## ON-SITE SEWAGE DISPOSAL SYSTEM HOWARD COUNTY HEALTH DEPARTMENT BUREAU OF ENVIRONMENTAL HEALTH

### 03-333426

SUBDIVISION: Brantwood 2/2 LOT NUMBER: 10

ADDRESS: 3132 Argent Path PROPERTY OWNER: NVR Inc.

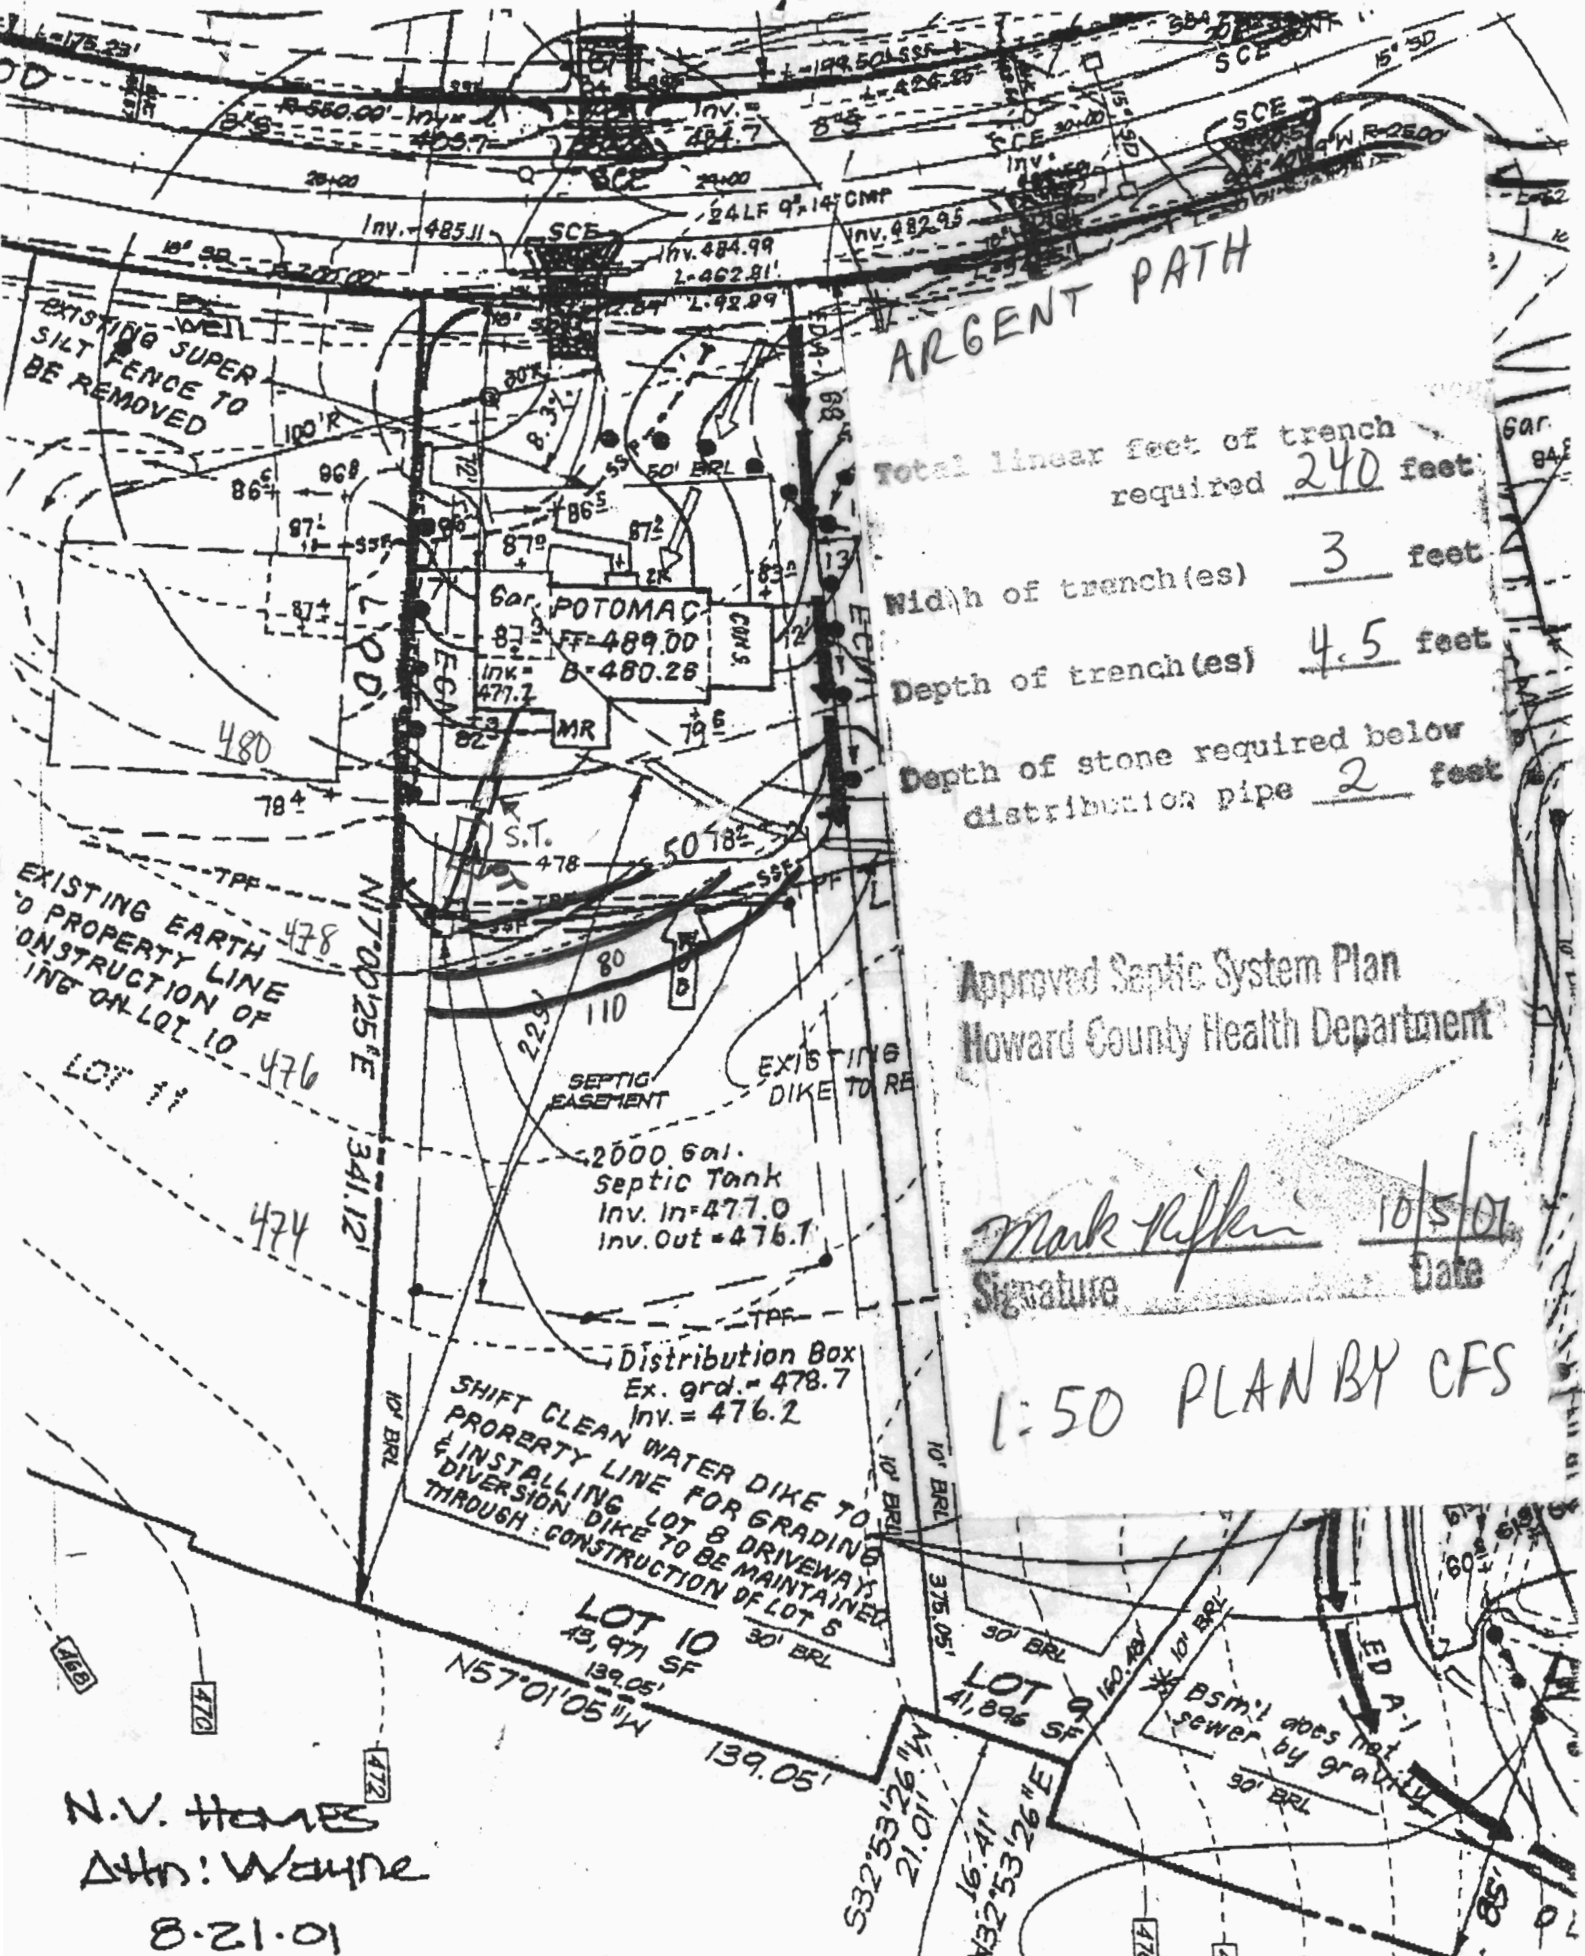
PRE-CONSTRUCTION INSPECTION: 12/21/01 Builder came out foundation: 1.5' to low.

Can't make inlet depth, pump tank needed. Trenches changed to (3) 36"

INSPECTION COMMENTS: 2/1/01 OK to cover to S.T. - P.T. set (2) (100)

12/26/01 OK to cover all work. Pump & alarm test needed

1/22/02 No clean out on D.B. Pump & Alarm tests OK (2) (50)

Approved Septic System Plan  
Howard County Health Department

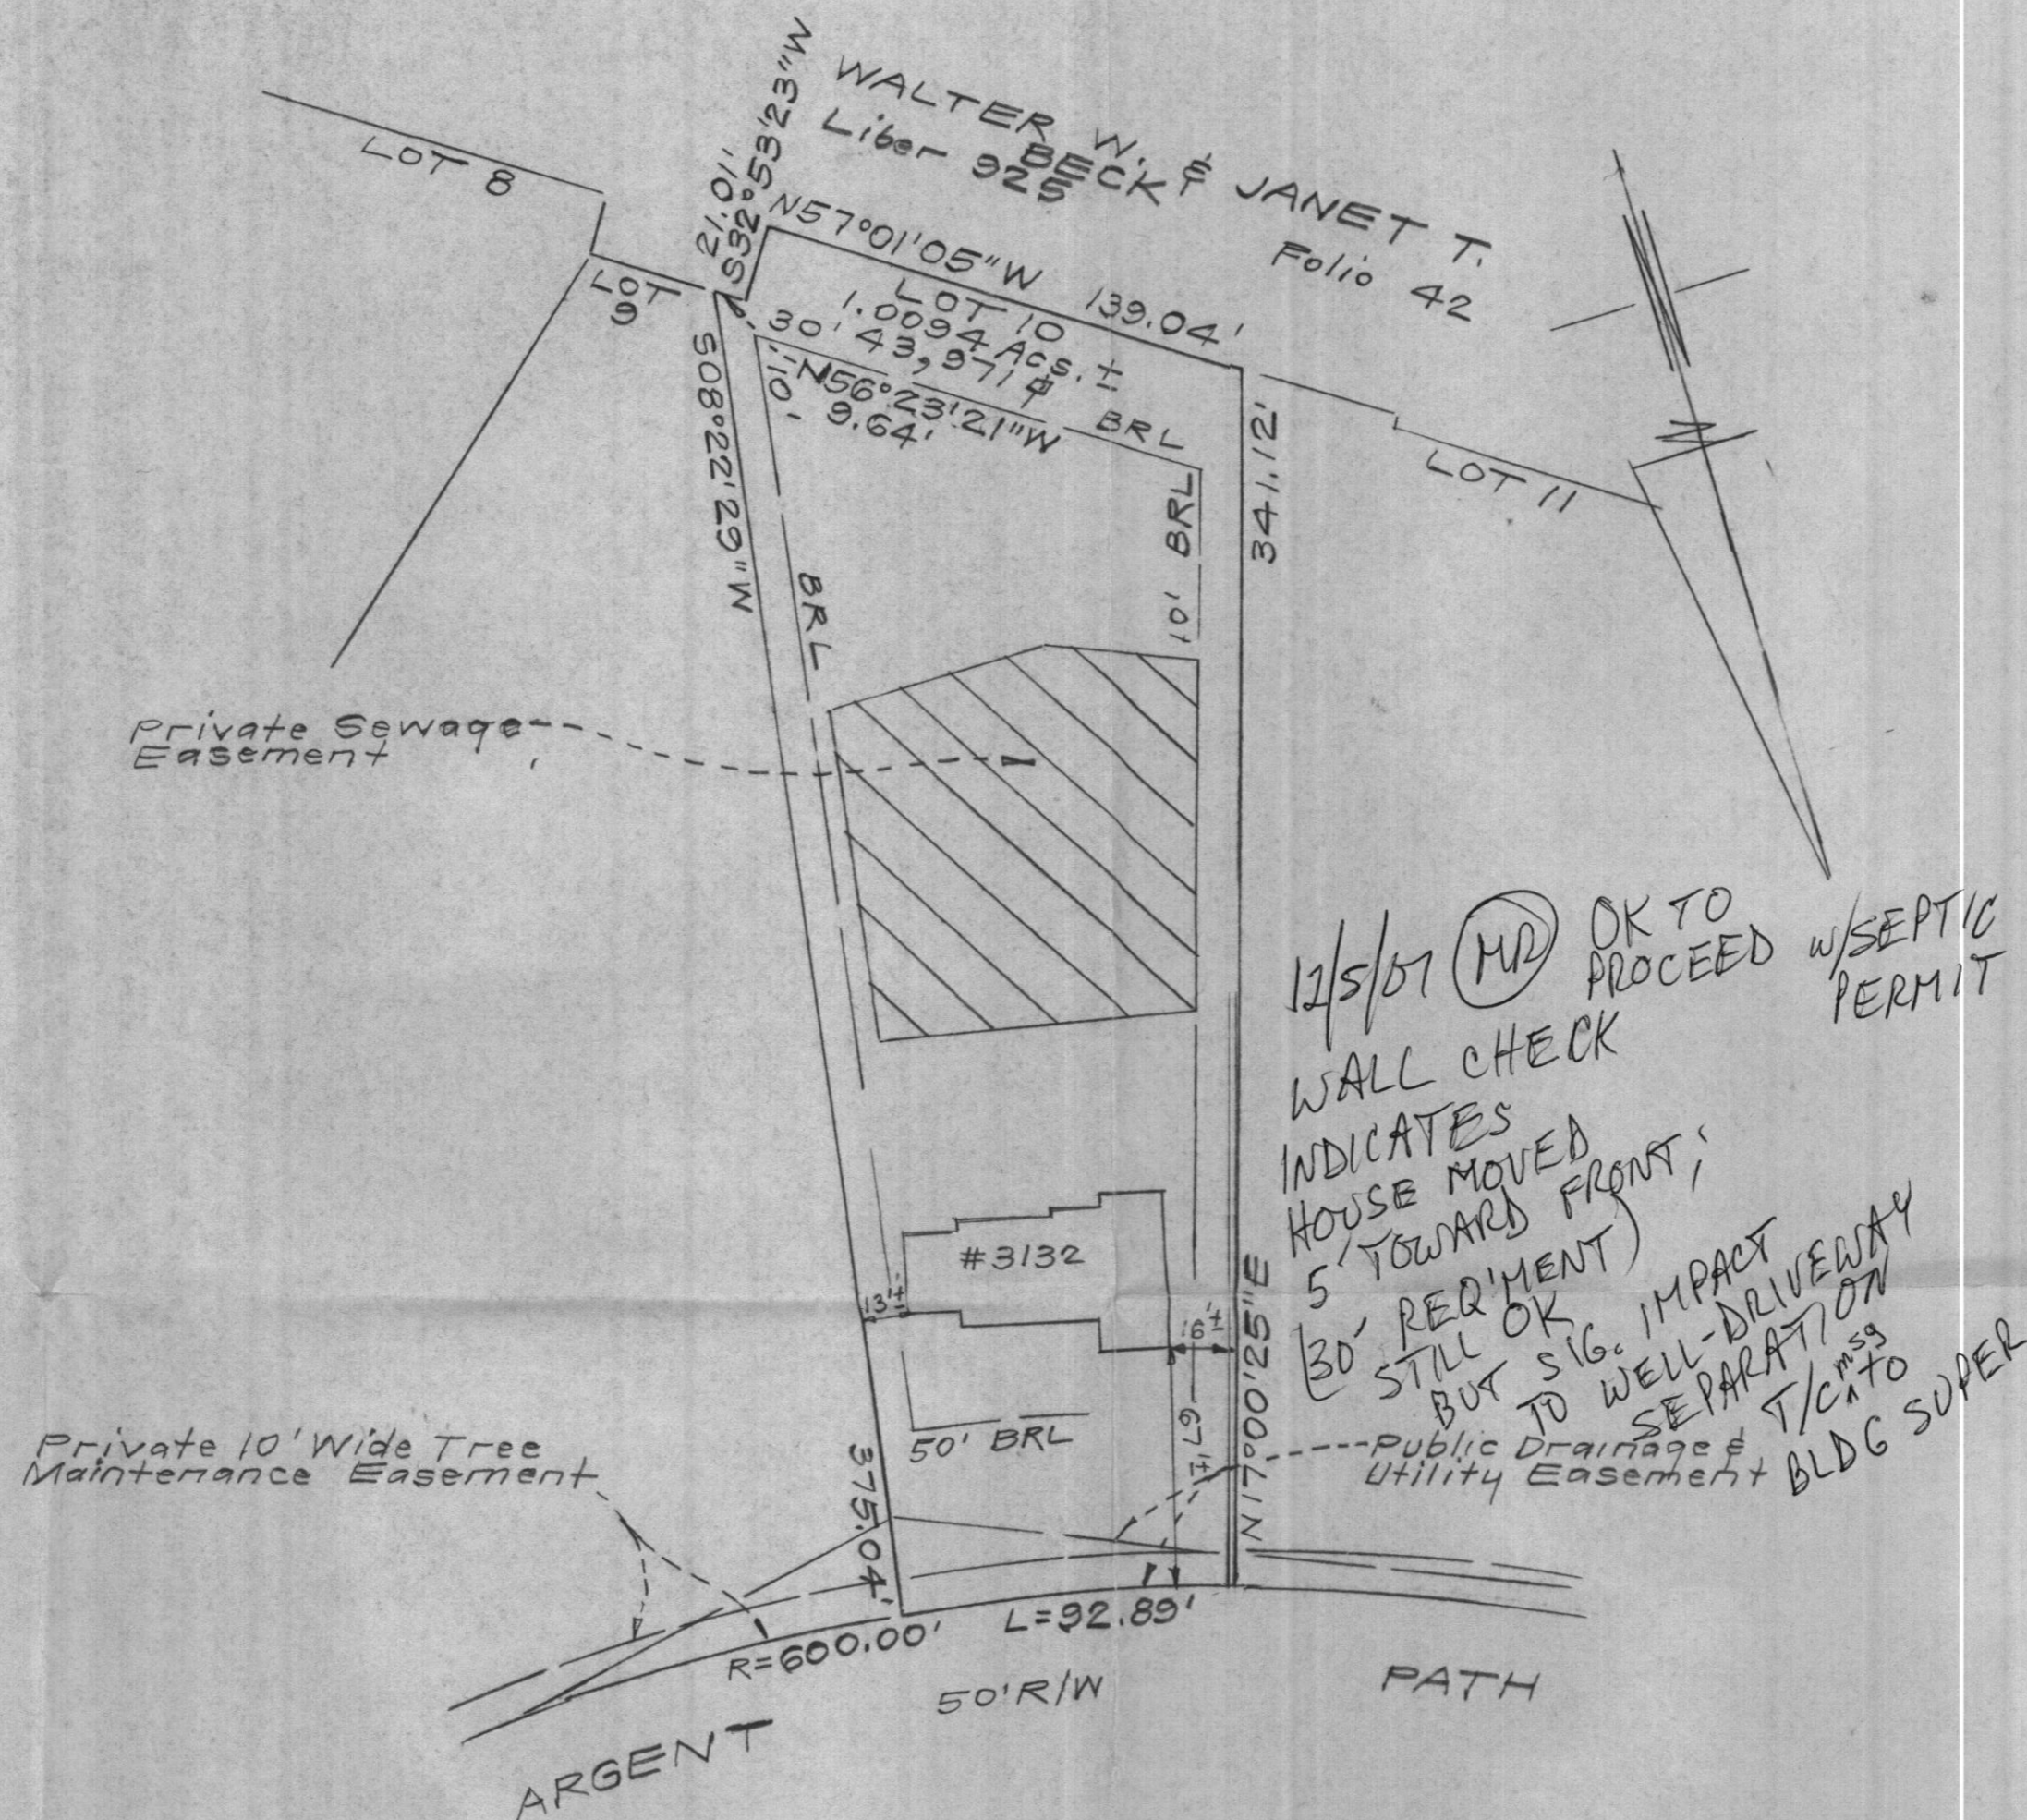
NO ICOP w/o  
WELL BARRIERS  
MR/SO  
12/21/01

TRENCHES:	Trench to be 3.0 feet wide. Inlet 2.5 feet below original grade. Bottom maximum depth 4.5 feet below original grade. Effective area begins at 2.5 feet below original grade. 3.0 feet of stone below distribution pipe.
LOCATION:	Place the distribution box 165' down the right lot line and 10' off this same lot line. Run (3) trenches on contour to center of lot as shown on plan.
NOTES:	WELL BARRIER REQ'D DUE TO HOUSE ADJUSTMENT PREFER PRIOR TO SEPTIC APPROVAL ABSOLUTELY REQ'D PRIOR TO ICOP MR 12/5/01

Total linear feet of trench required 240 feet

Width of trench(es) 3 feet

Depth of trench(es) 4.5 feet

Depth of stone required below distribution pipe 2 feet
